# ***Interactive comment on “Greenhouse gas flux studies: An automated online system for gas emission measurements in aquatic environments” by Nguyen Thanh Duc et al.***

**Werner Eugster (Referee)**

Received and published: 6 May 2019

**Fig. 1.** Unpublished example of a time series with my test chamber deployed at a few ponds near Toolik Lake, Alaska, on 3 July 2015. The top panel shows the raw voltages from a TGS2600 sensor.

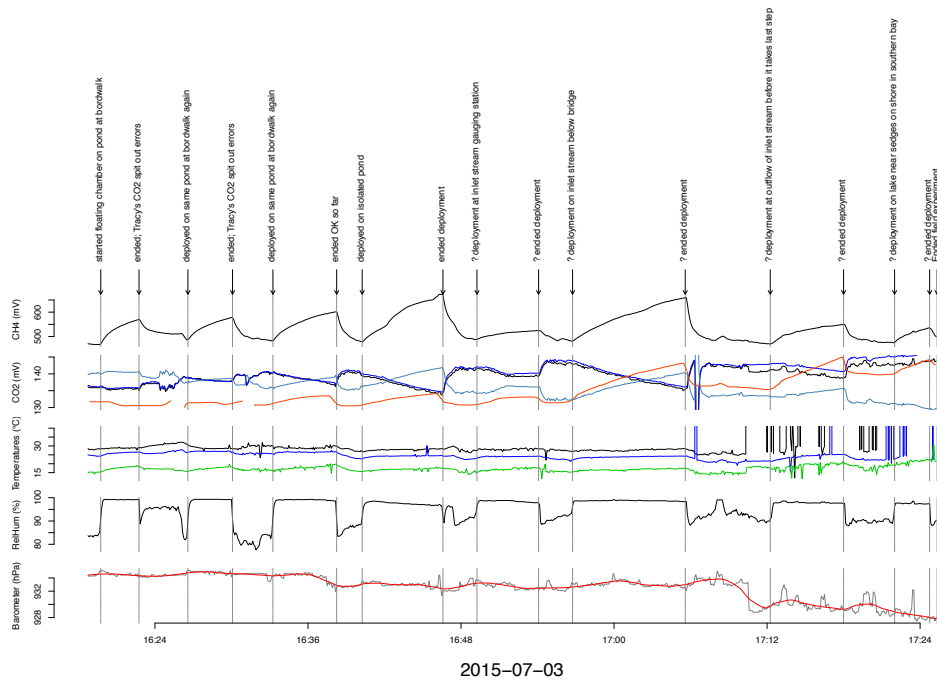
3. The authors only sample data every minute, which I find utterly coarse. They may have a reason for this, but in my own tests with the TGS2600 a one-minute measurement interval **in combination** with a 5-minute data rejection after chamber deployment (page 6, line 26; this information should actually have been given in the Methods section already, because this is an essential flaw in the system in my view) I would have lost all the information relevant to chamber fluxes (see graph below and description of unpublished internal example graph from my experiments at Toolik Lake, Alaska, USA). Thus, the authors should more precisely describe their method and critically discuss such shortcomings to help others to do better.
